PLAN REVIEW COMMENTS FOR DP-09-22-017188

Town of Bluffton

BUCK ISLAND/SIMMONSVILLE

SITE DEVELOPMENT PLANS
FOR
CROWNE AT BUCK ISLAND
APARTMENTS
BLUFFTON, SOUTH CAROLINA

L12

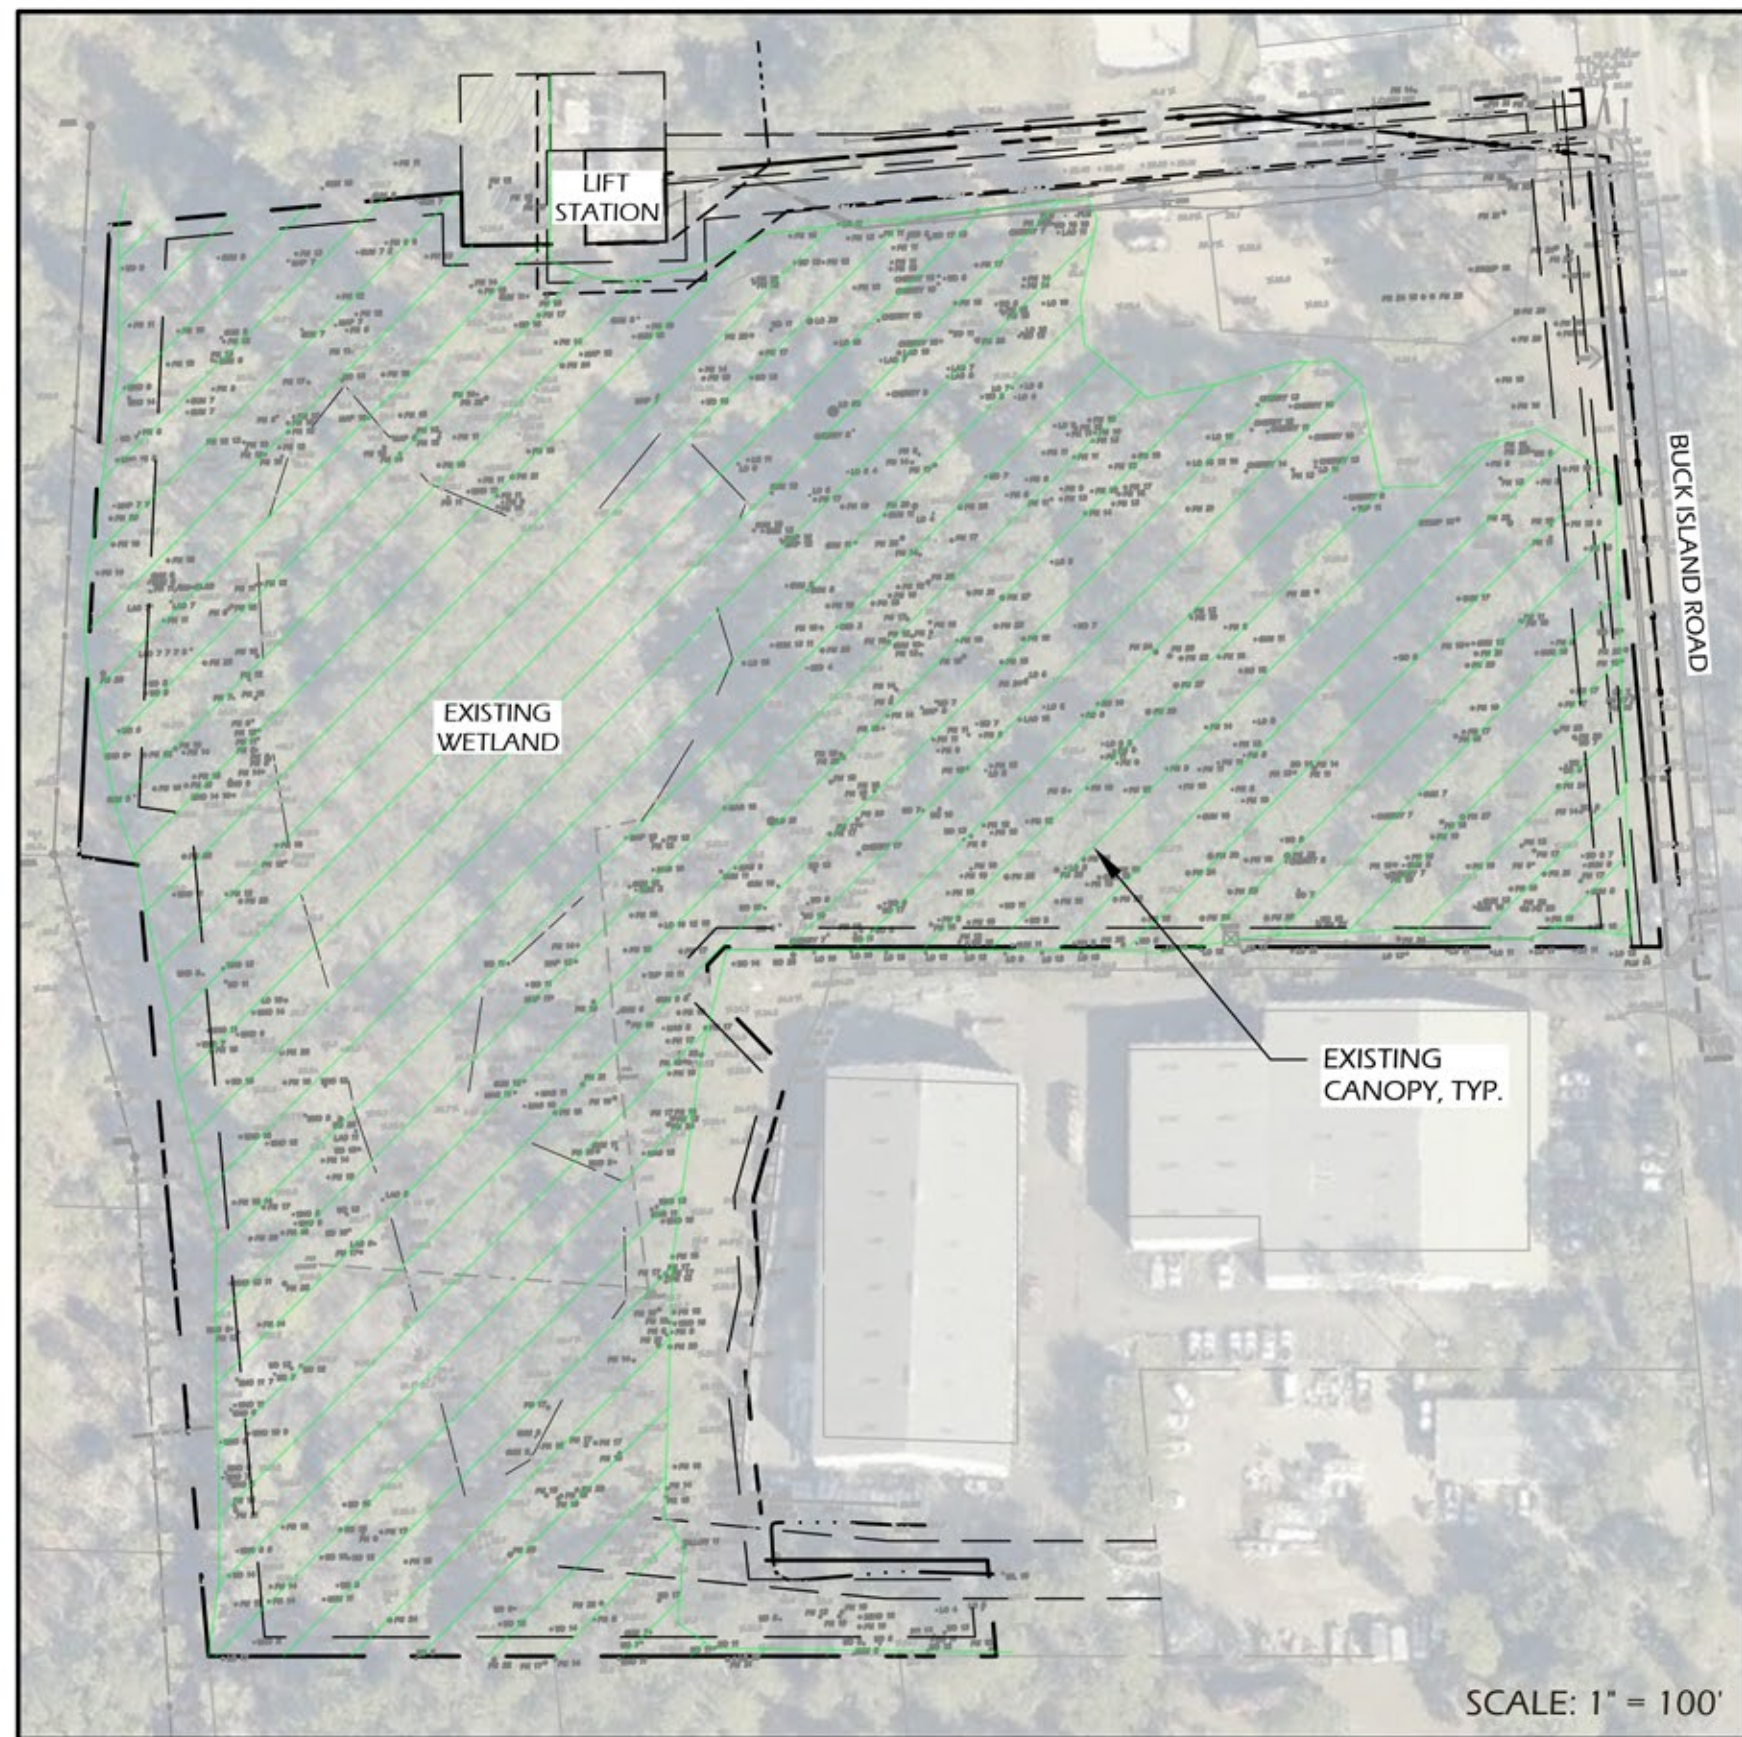
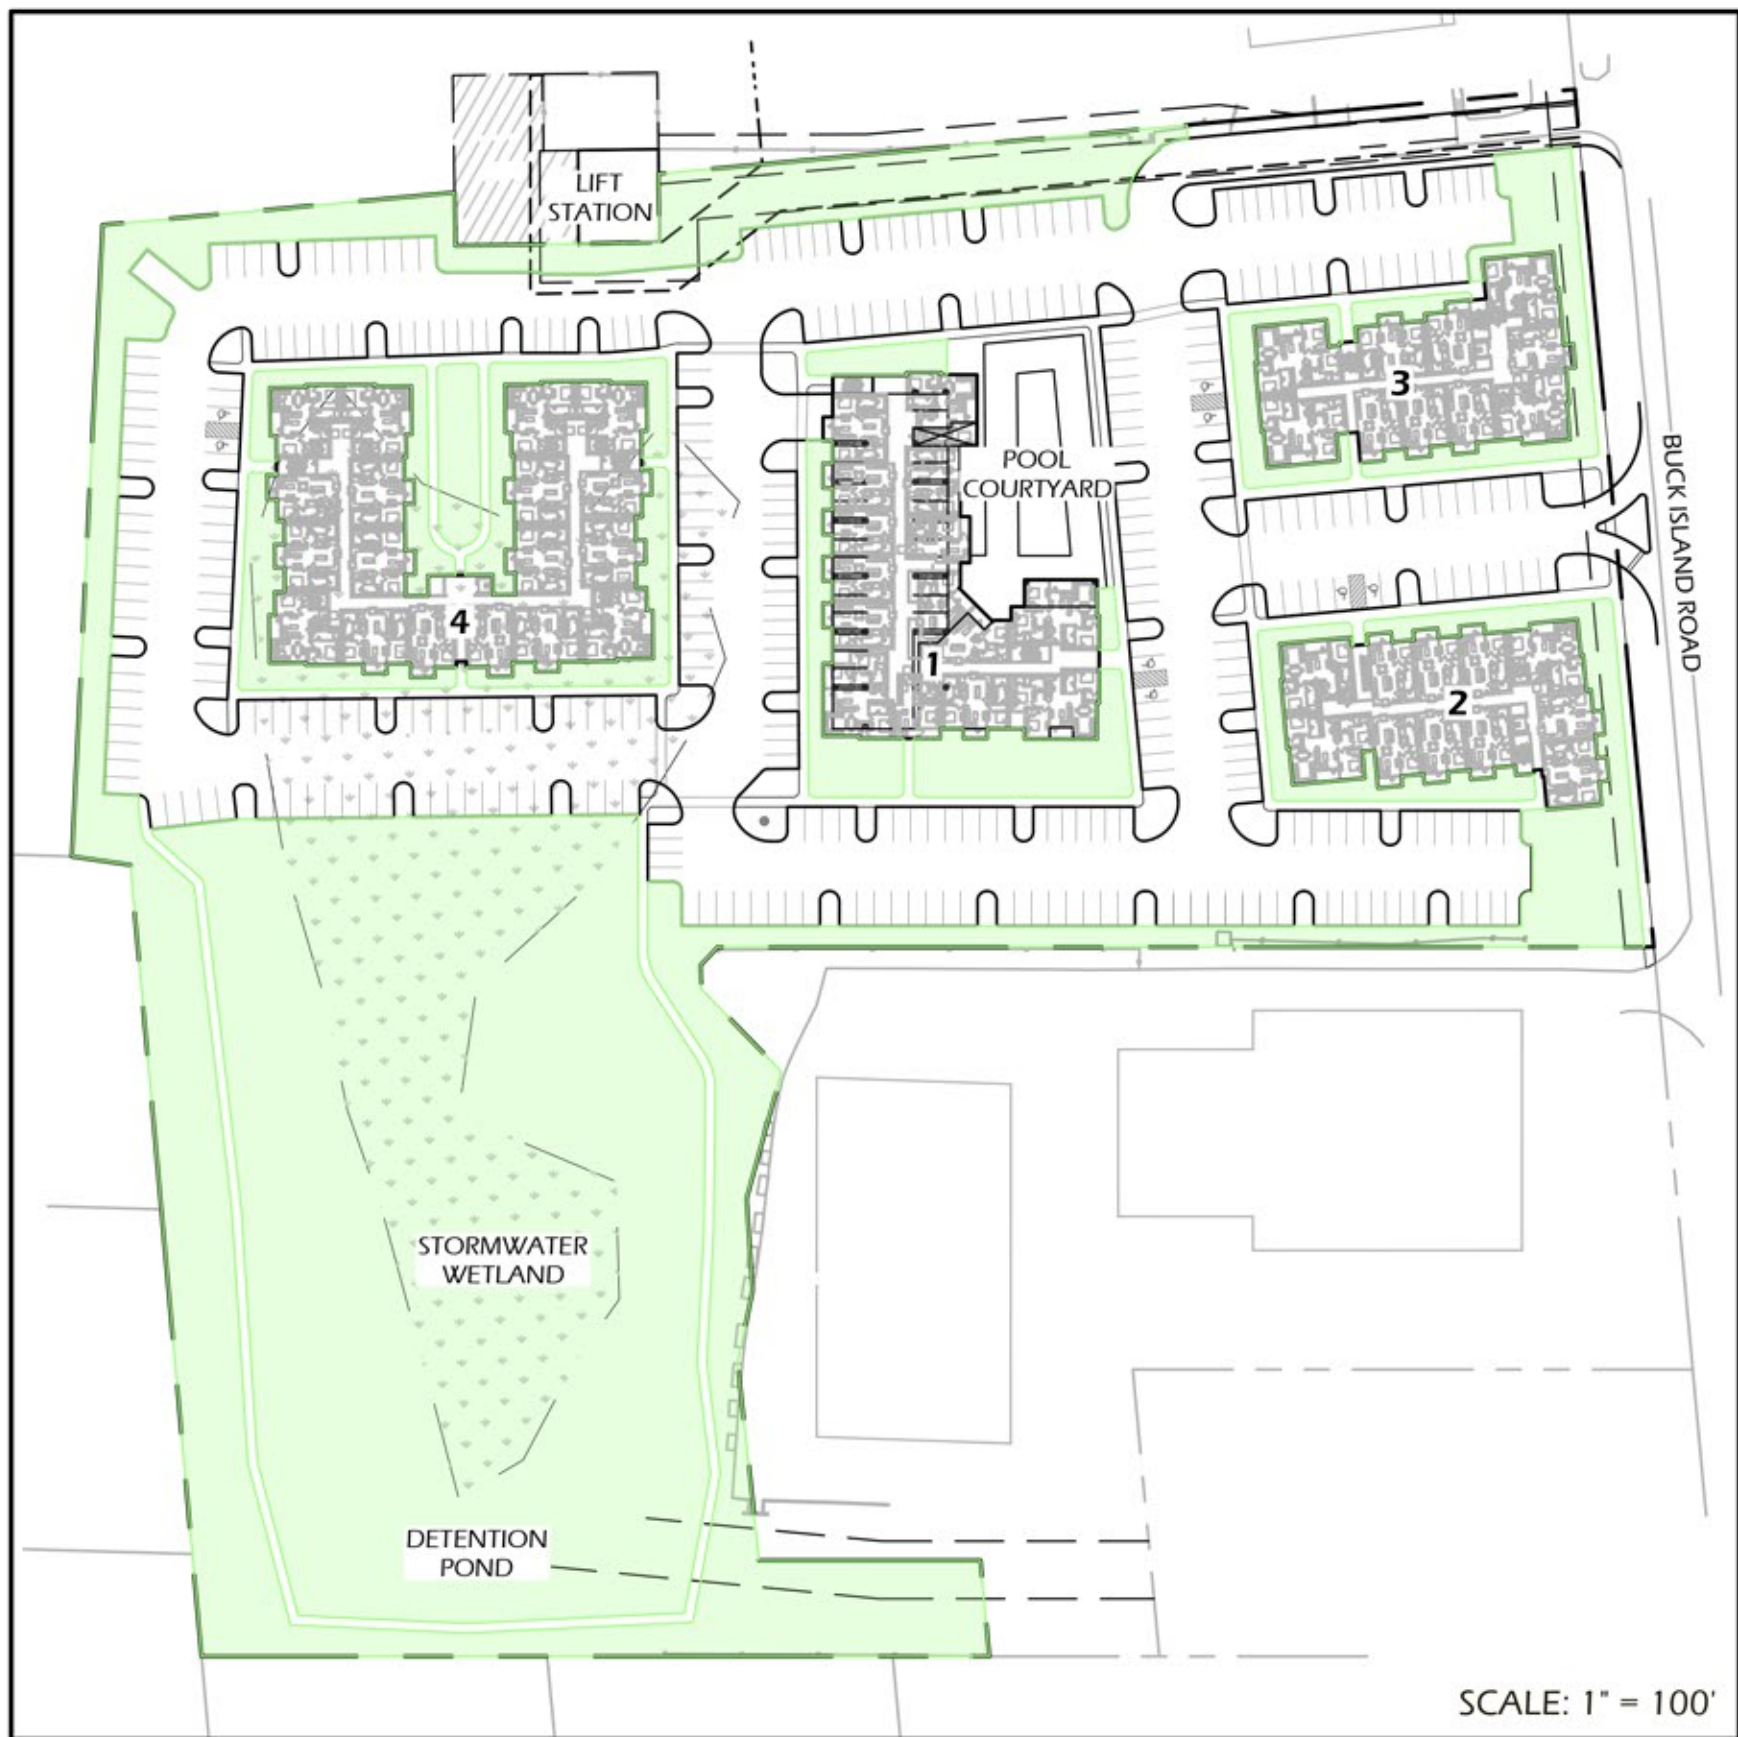
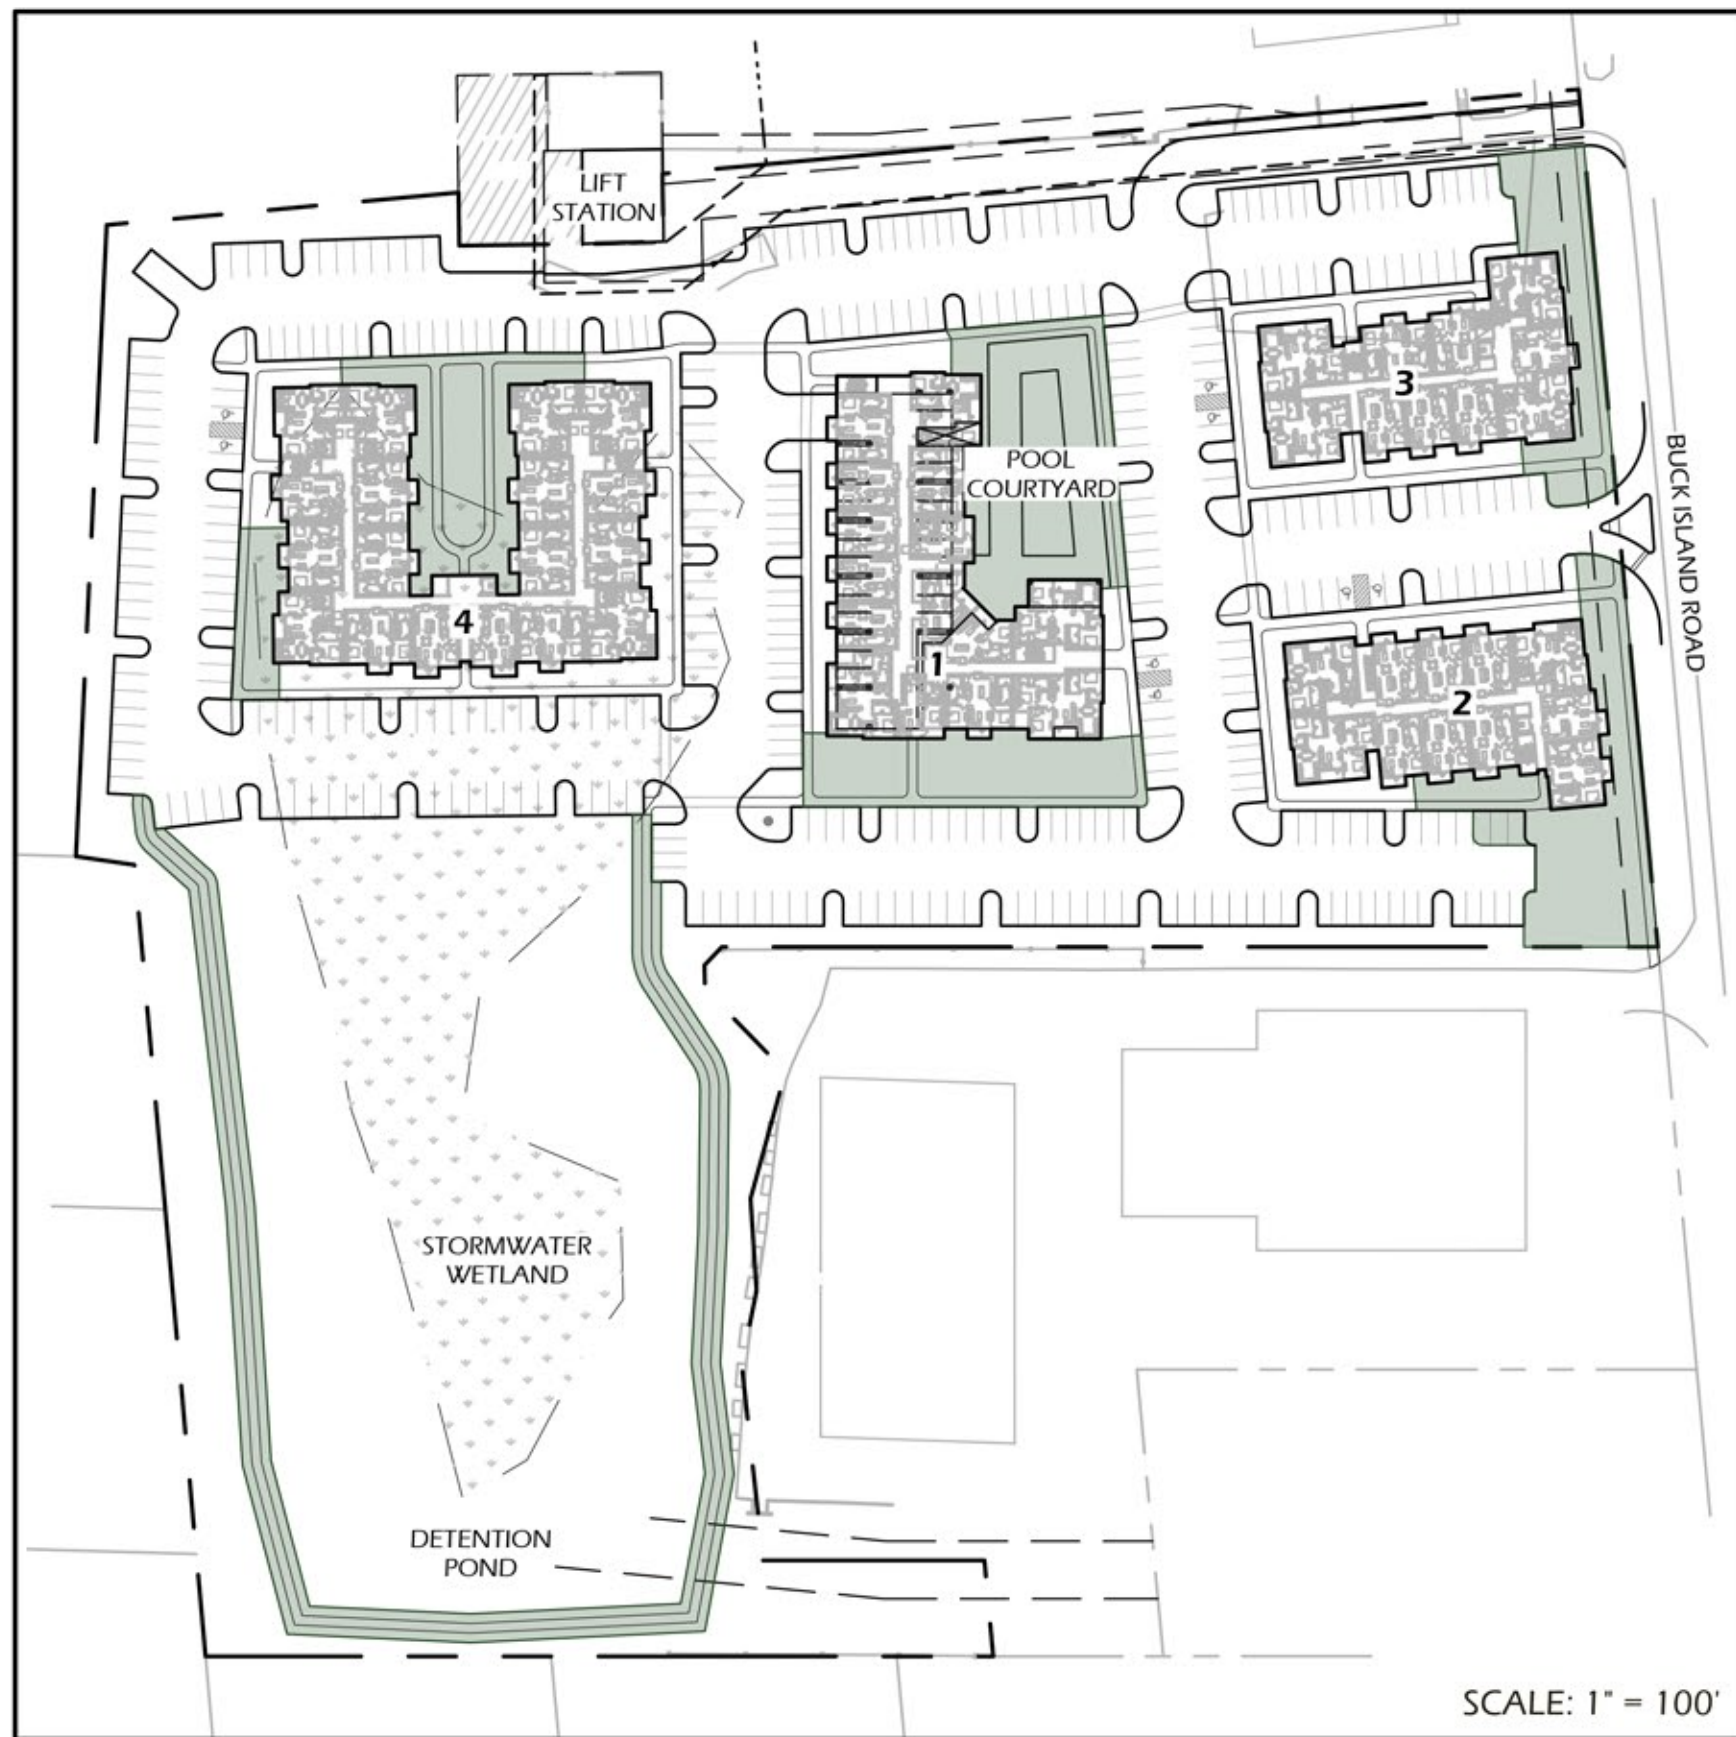
12. Wheel stops shall be provided in all parking facilities without curbing (UDO Section 5.11.4.A.4).
13. Demonstrate how the common open space identified on Sheet L12 meets the common open space requirements of UDO Section 5.6.4.
